LAND USE APPLICATION SUMMARY

Property Location: 419 Lake St E
Project Name: Lake Plaza
Prepared By: Shanna Sether, Senior City Planner, (612) 673-2307
Applicant: Basim Sabri
Project Contact: Brian Houwman
Request: To construct an addition and new parking garage for an existing shopping center.

LANDSCAPING PLAN
A1.1

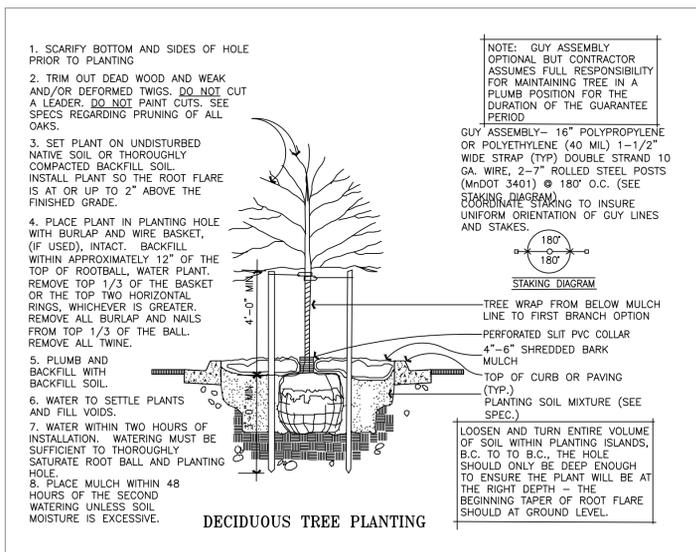
- The applicant is not proposing at least one canopy tree per 500 square feet of the required landscaped area, including all required landscaped yards. The tree requirement for the site is 3 and the applicant is proposing a total of 6 ornamental trees, but 0 canopy trees. The applicant is requesting alternative compliance. Staff finds there is sufficient space in the required landscaped yards to provide three canopy trees.

- Canopy trees.** The applicant is not proposing at least one canopy tree per 500 square feet of the required landscaped area, including all required landscaped yards. The tree requirement for the site is 3 and the applicant is proposing a total of 6 ornamental trees, but 0 canopy trees. The applicant is requesting alternative compliance. Staff finds there is sufficient space in the required landscaped yards to provide three canopy trees.

5. The applicant shall provide a minimum landscaped area of 656.8 square feet, 3 canopy trees and 15 shrubs as required by Chapter 530 Site Plan Review.

PHASE 1
 PARKING RAMP
 BUILDING
 ELEVATIONS
A3.0

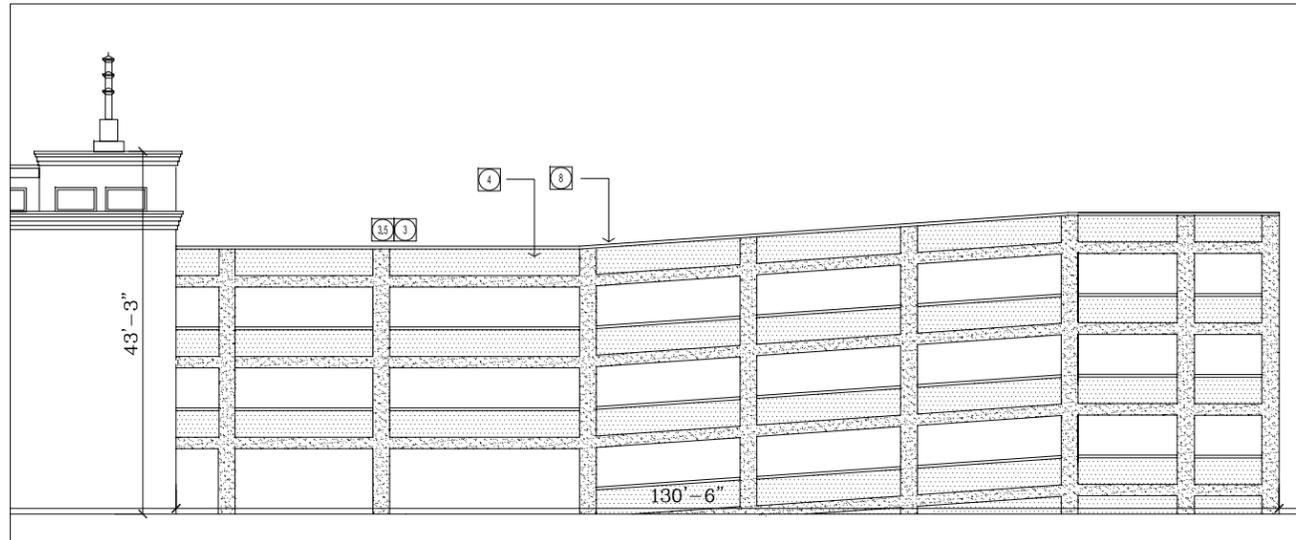
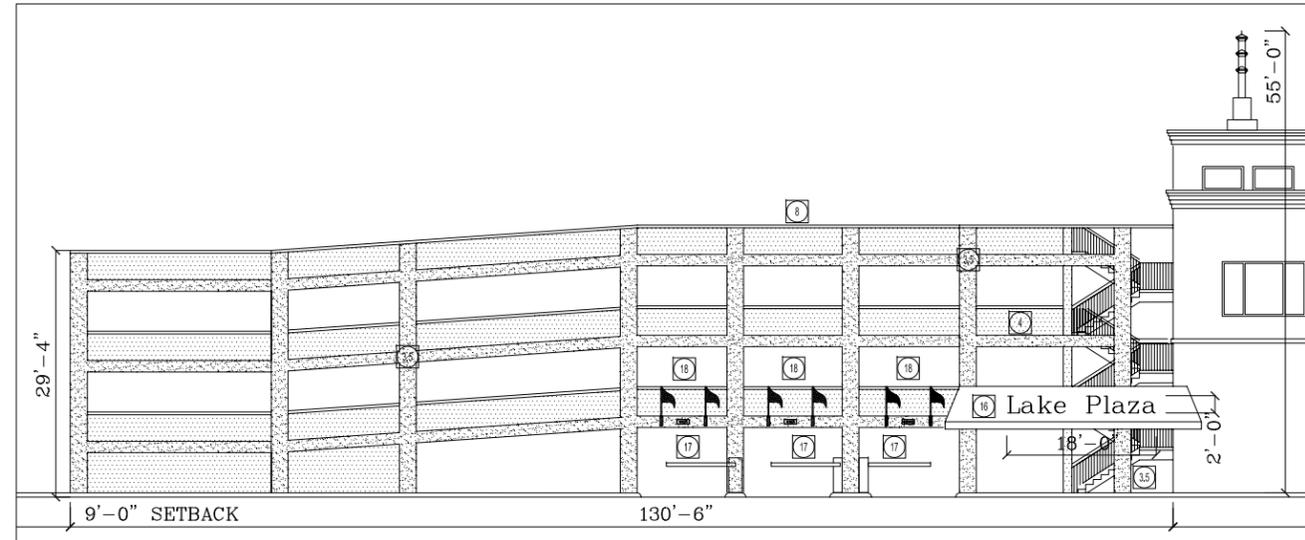
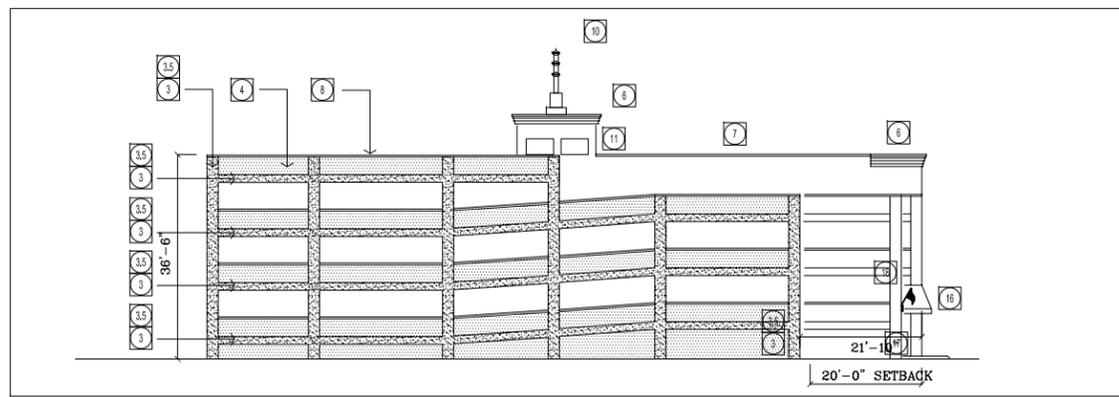
- All of the proposed parking is located in a new three-story parking garage, at the rear of the existing shopping center.
- As proposed, sloped floors would dominate the appearance of the walls on the parking garage, and the applicant is not proposing to screen the sloped floors or vehicles from view. Staff is recommending that the applicant provide a decorative metal screen between the floors to disguise the sloped floors and vehicles from the public sidewalk, street and residential uses across 5th Ave S.

- **Sloped floors of the parking ramp.** As proposed sloped floors would dominate the appearance of the walls on the parking garage, and the applicant is not proposing to screen the sloped floors or vehicles from view. Staff is recommending that the applicant provide a decorative, perforated metal screen between the floors to disguise the sloped floors, vehicles, and lighting from the public sidewalk, street and residential uses to the south and across 5th Ave S.

4. The applicant shall provide a material or color on all three exposed sides of the exterior of the parking ramp to ensure compatibility with the existing shopping center and add a decorative, perforated metal screen between the floors to disguise the sloped floors and block headlights and parking ramp lighting impacts from the adjacent residential uses to the south and east.
